AMENDMENT 1

**Information technology – Telecommunications cabling requirements for remote
powering of terminal equipment**

IECNORM.COM : Click to view the full PDF of ISO/IEC TS 29125:2017/Amd 1:2020

This amendment incorporates changes necessary to include remote powering using single pair cabling.

Figure 3 – Temperature rise for a 0,57 mm conductor diameter 1-pair cable versus current for different bundle sizes in air

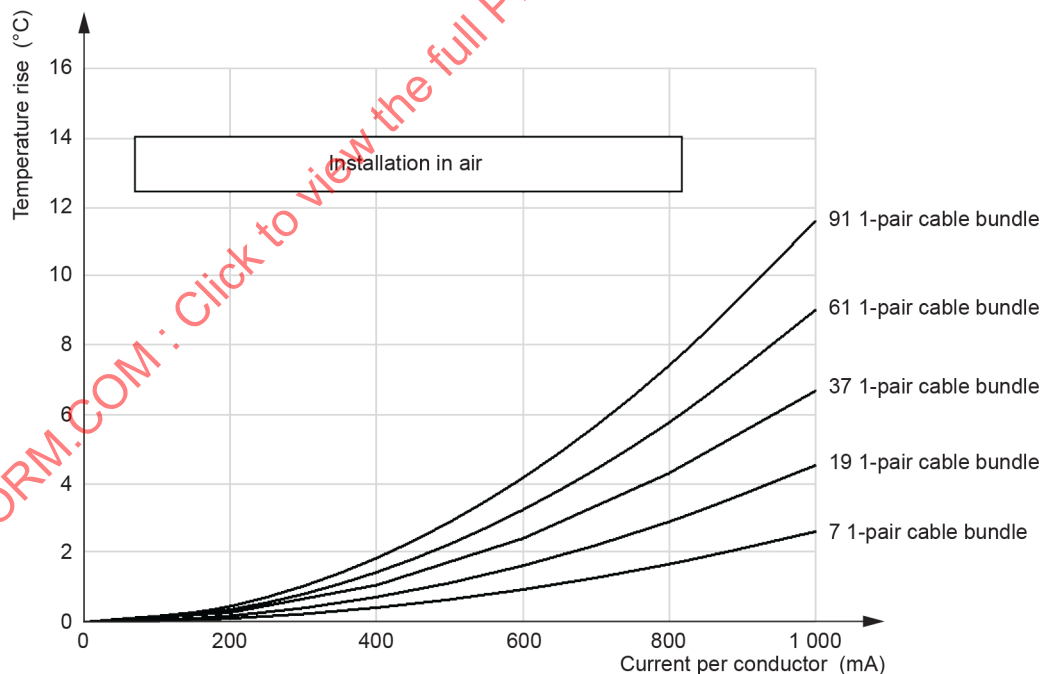
Table 8 shows the effect of energizing the number of pairs within a 37-cable bundle for different 1-pair cable constructions in air. Figure 1 shows this data in graphical form.

Insert the following new Figure 3 after Table 8:

**Figure 4 – Temperature rise for a 0,57 mm conductor diameter
1-pair cable versus current for different bundle sizes in conduit**

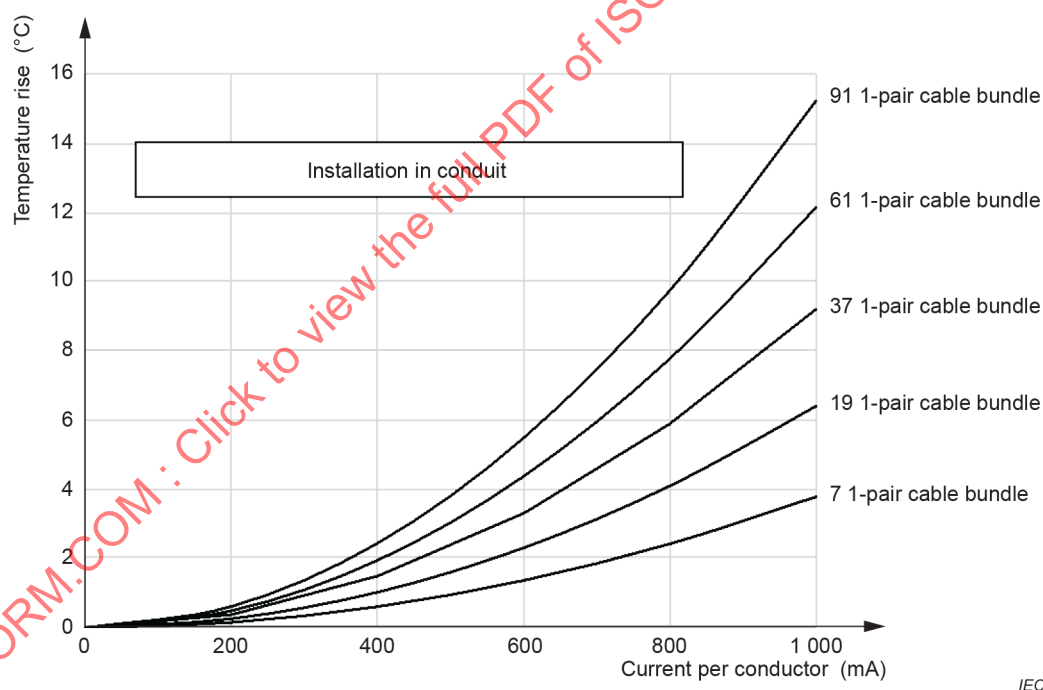
Table 9 shows the effect of energizing the number of pairs within a 37-cable bundle for different 1-pair cable constructions in conduit. Figure 2 shows this data in graphical form.

Insert the following new Figure 4 after Table 9:

Figure 5 – Single pair remote powering using signal pairs

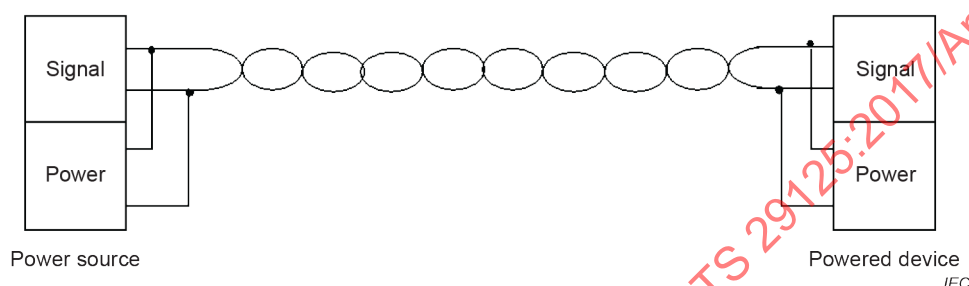
7.2 1-pair balanced cabling

Figure 5 shows examples of specified transmission paths used in 1-pair balanced cabling. The channel is the transmission path between equipment such as a LAN switch or hub and the terminal equipment. The channel does not include the connections at the data source equipment and the terminal equipment. The channel, the permanent link or the CP link shall meet the transmission requirements specified in the design standards.

Remote power may be provided to terminal equipment via balanced cabling equipment interfaces. Remote power is introduced to the balanced cabling channel at the Floor Distributor using the phantom circuit of data pairs from the power sourcing equipment, as shown in Figure 5.
